Bid Addendum

Addendum No. 3 for the City of Staunton Gardner Spring Pump Station, Augusta County, VA.
Wiley|Wilson Comm. No. 220117.00.

Addendum Date: September 2, 2022

CSK-01

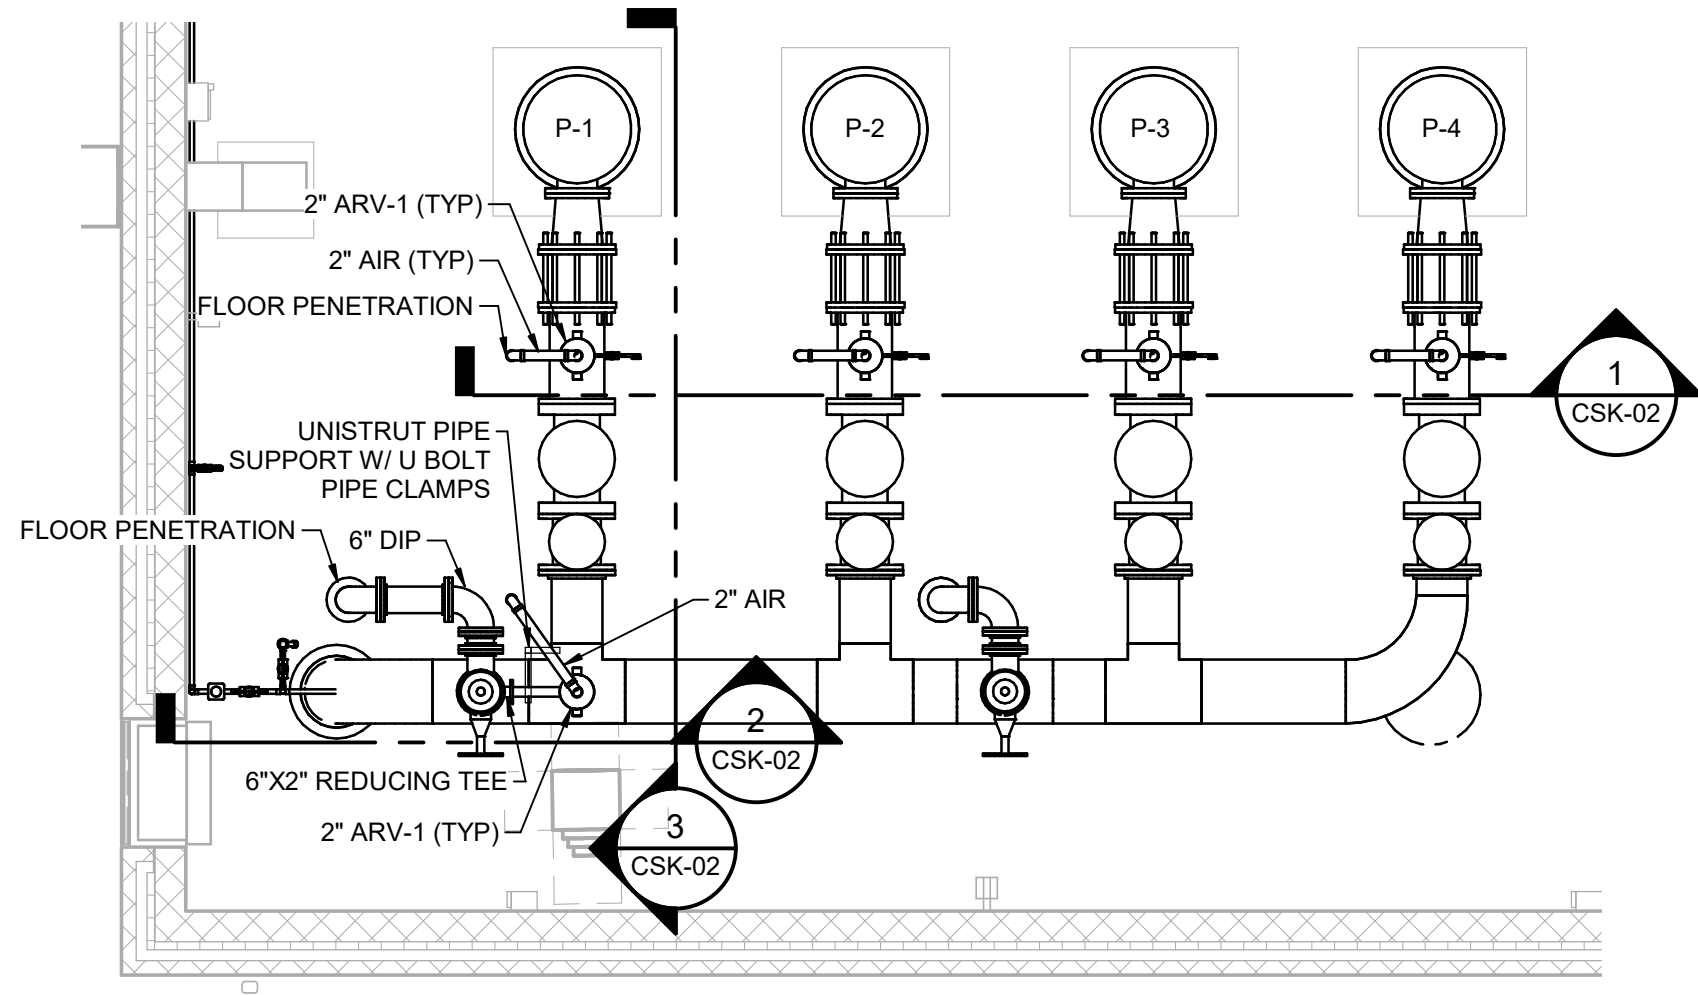
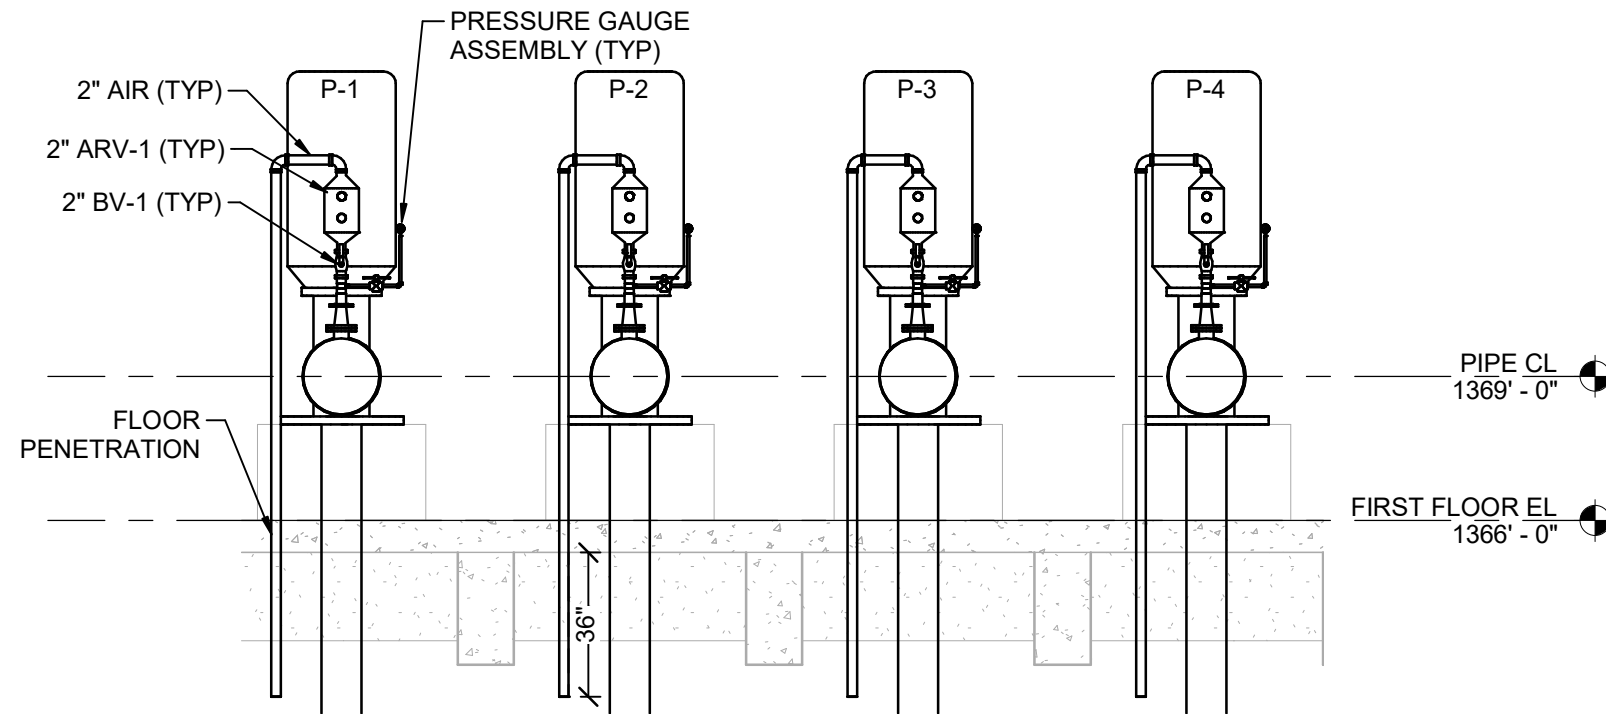
Question 21: Drawing D-302 shows a common two (2) inch air release manifold. This will allow air to be expelled through the idle pump air/vacuum valves and into the pump interiors. We recommend the air discharge should be separate lines terminated well above the highest possible water level of the wet well. Is this acceptable?

Response: Contractor must provide air release valve piping to provide individual air lines for each valve as shown in Sketches SK-01 and SK-02 attached to this addendum.

1. Provide an air release valve with isolation ball valve on the pump station discharge header and dedicated air release valve piping as shown in Sketches CSK-01 and CSK-02 .
Revise all relevant drawings to reflect this change.
2. ADD the following general note to Drawings D-101, D-301, and D-302: *“Contractor must provide cast in sleeve and link seal for all pipe penetrations through the pump room floor, except for the 18” diameter observation port. Contractor must provide 18” diameter flanged wall pipe cast into the floor and reinforced in the same manner as other wall pipes for the 18” diameter observation port.”*
